# SOFTWARE SUMMARY FORM

18. Computer Memory Requirements: UNKNOWN	19. Tape Drives: NONE	20. Disk/Drum Units: N/A	21. Graphics: UNKNOWN
22. Other Operational Requirements  NONE

# SLIM Fortran Program Static and Dynamic Analysis

Earl S. Marwil  
John E. Tolli  
Scientific Computing Unit  
Idaho National Engineering Laboratory

## PERFORMANCE DATA FOR SLIM

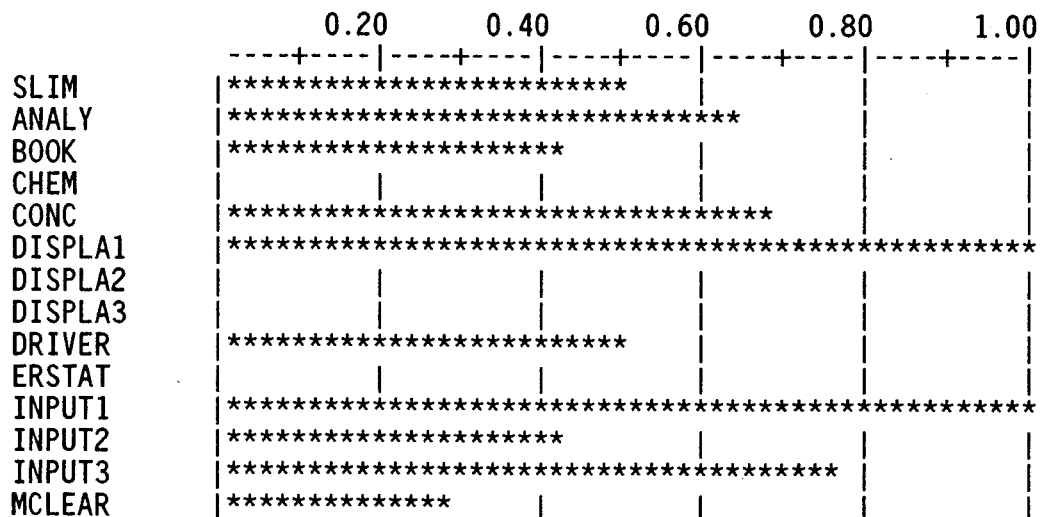
The performance data show that a high percentage of the overall execution time (90.959%) is spent in the first 3 routines listed. This is due primarily to a low percentage of floating point operations which are performed in vector mode (%Vflops is small). A detailed optimization analysis effort should focus on this area.
